Change Order Request

Williamson County Expo Center
210 Carlos G. Parker Blvd, NW

Change Order Request: 004

Owner Change Order 004 - Incorporates Alternates #1 & #3 & additional scopes requested by Williamson County. Due to the schedule impacts of Alternate #1 Covered Penning. Flintco is requesting 78 calendar days which moves the contractual substantial completion from June 21, 2016 to September 7th, 2016.

14 3803 POPULOUS®
9/16/2015
SOUTHEAST AREA
PLAN
A2-1A

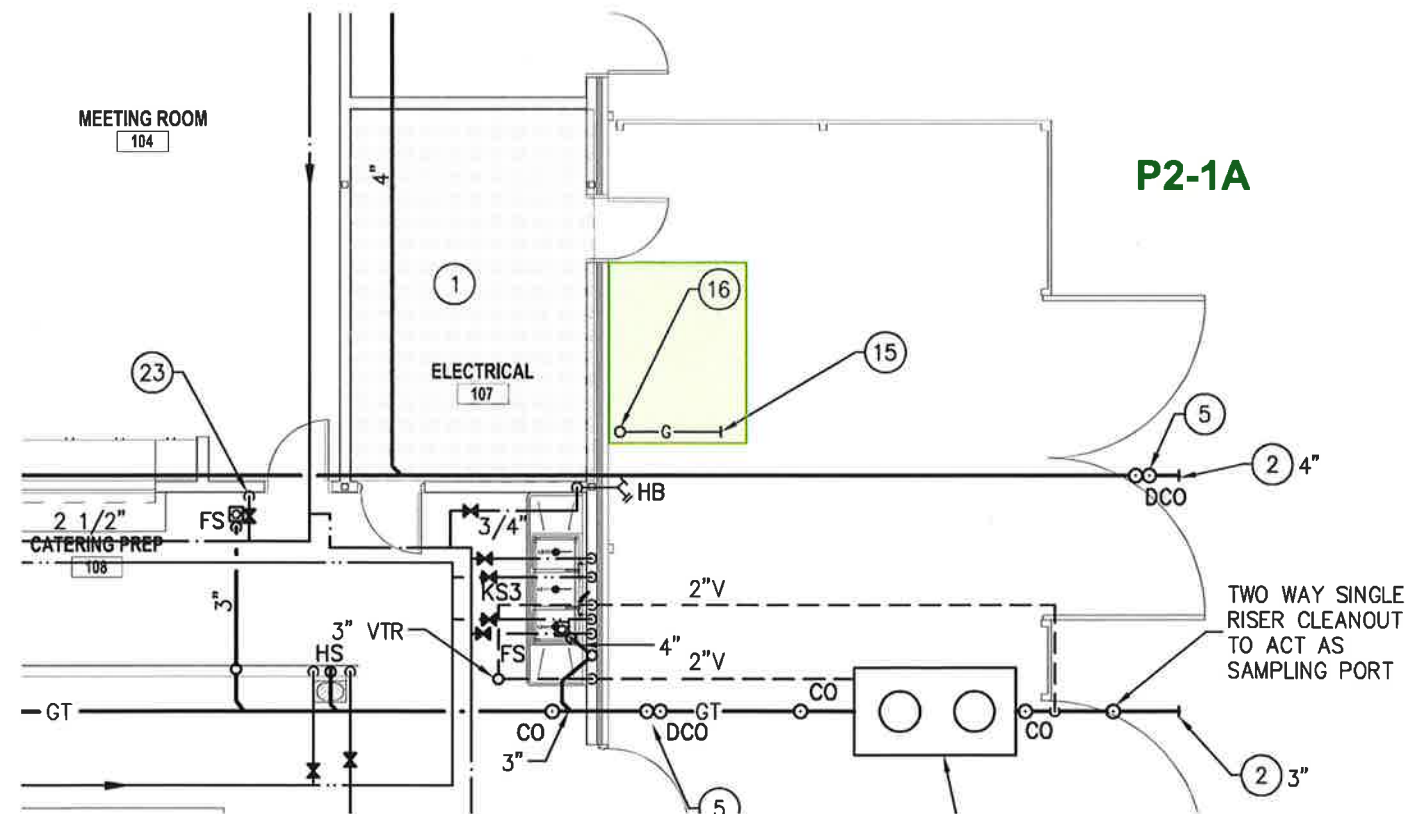
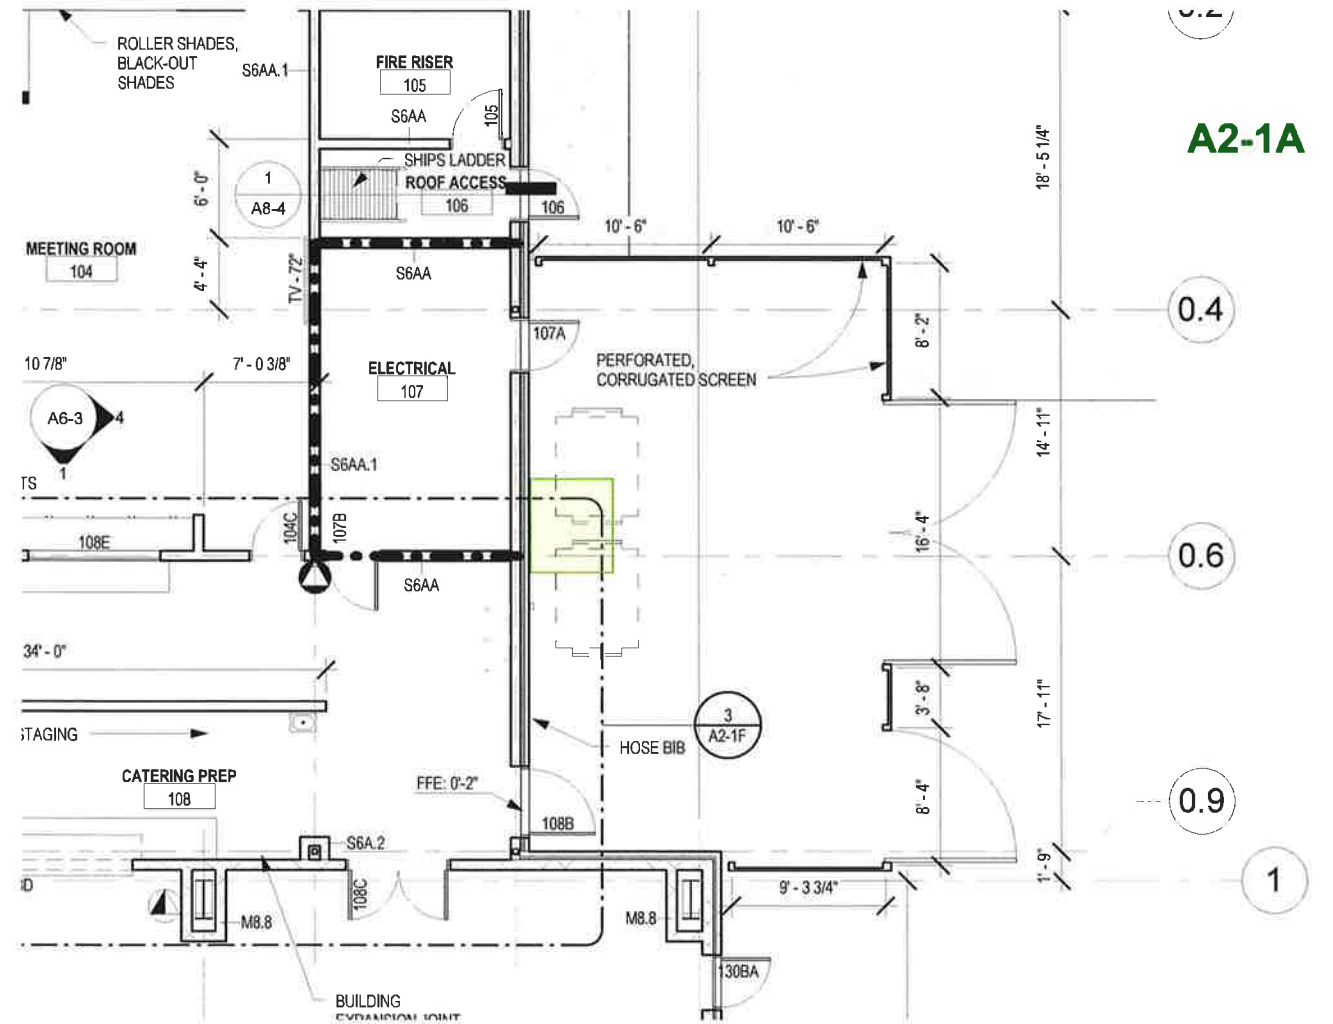
Ref: P2-1A & A2-1A

P2-1A Note #16 shows a propane line running up the wall to the roof in the dumpster area. A2-1A does not reflect any protective bollards for the propane line. Please confirm locations of protective bollards for propane line.

Add 2 bollards per revision in attached sheet A2-1A.
